Field Safety Notice

MR systems with SW versions R11.1 and R12.1
MobiView cross reference alignment errors

Figure 1. Cross reference line of the axial image (left) is at the incorrect location on the MobiView generated image (middle). The correct location is shown on the non-fused sagittal source image (right).

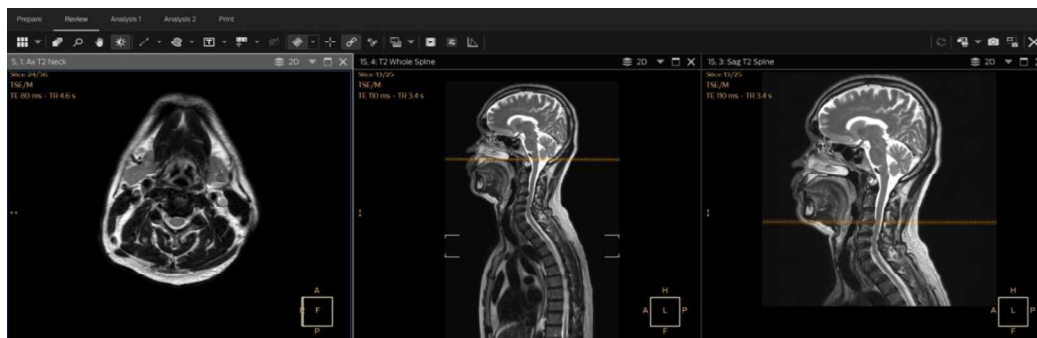
- A. The cross reference line and/or box may be shown at an incorrect location when displayed on a MobiView generated image (see examples in Figure 1 and 2).

- Multi-station scans that require stitching 3 or more station images, and
- Scan protocol is used where stations have different voxel size or field of view (i.e. voxel size or field of view is customized based on anatomy per station).

- You may continue to use your system(s) in accordance with the intended use.
 - A. To avoid the potential issue of an incorrect cross reference line in MobiView generated images, use the same voxel size and field of view across all station scans.

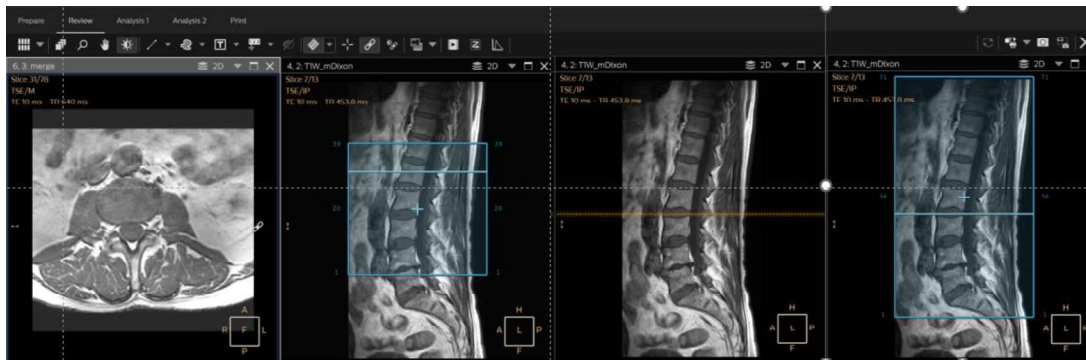
- B. The cross reference box of a MobiView generated image may be shown at an incorrect location when mirrored on to another image (see examples in Figures 3 and 4), if:
- the MobiView images are acquired with reversed slice scan order (i.e. image display settings are customized), or
 - displaying the cross reference box of a MobiView generated merged series (axial stations), or
 - displaying the cross reference box of multi-planar reformats generated from multi-stack data.

- B. Do not use cross reference line functionality in box mode, all slices mode, or 3D mode. Use the cross reference line functionality in single slice mode.
